Buckden, Silver Street, Development Application Number: 18/02753/OUT

Buckden Parish Council (BPC) – Further Comments to HDC

December 2020

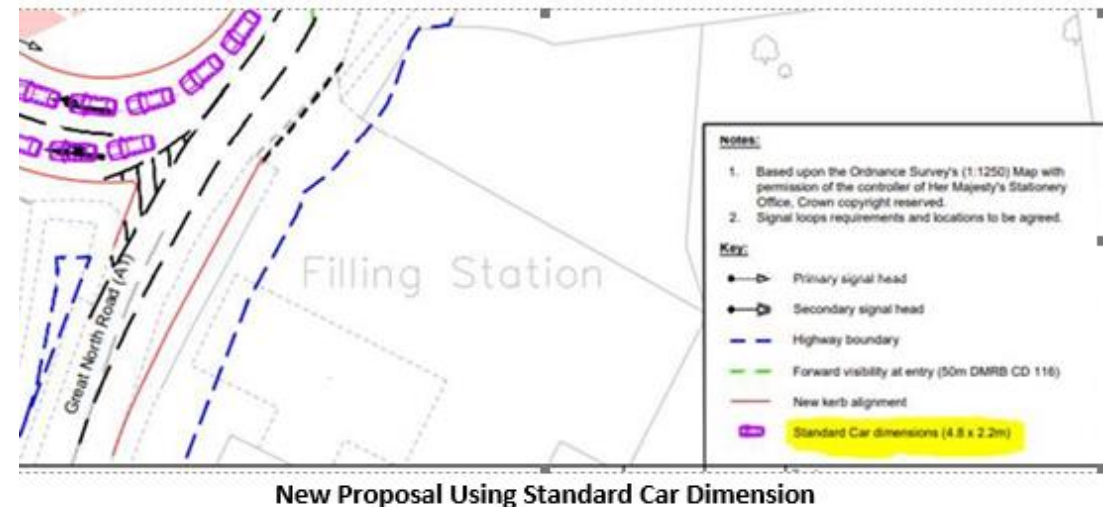
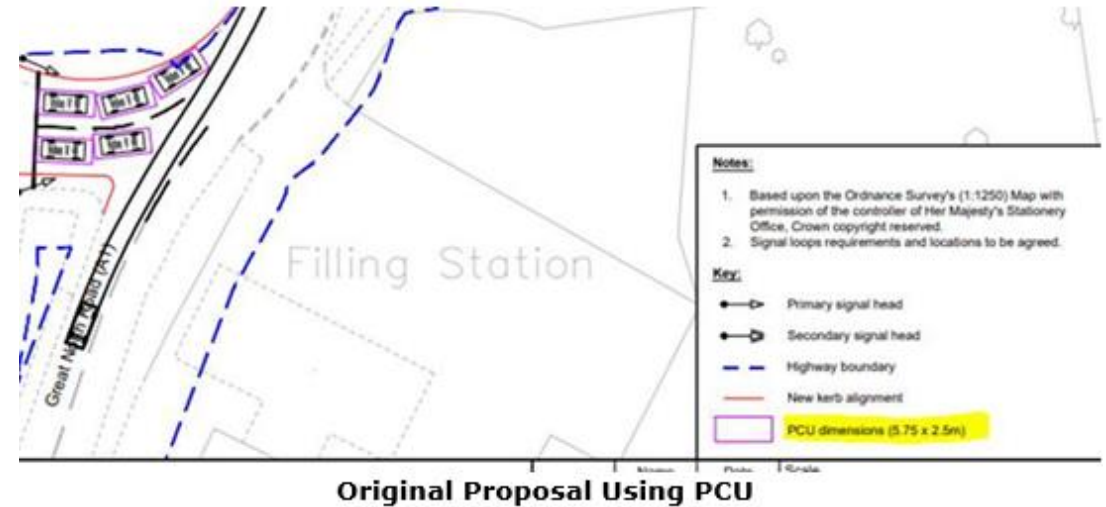
- Realignment and flattening of the roundabout curves, particularly on the western, Perry Road side, means that, when lights are at green, northbound traffic can pass through the roundabout at close to 50mph (see illustration).
- This presents a major risk to traffic joining the roundabout from Perry Road where drivers, used to traffic approaching the junction at much lower speeds, misjudge the speed of the oncoming traffic, resulting in a serious, and potentially fatal, collision.
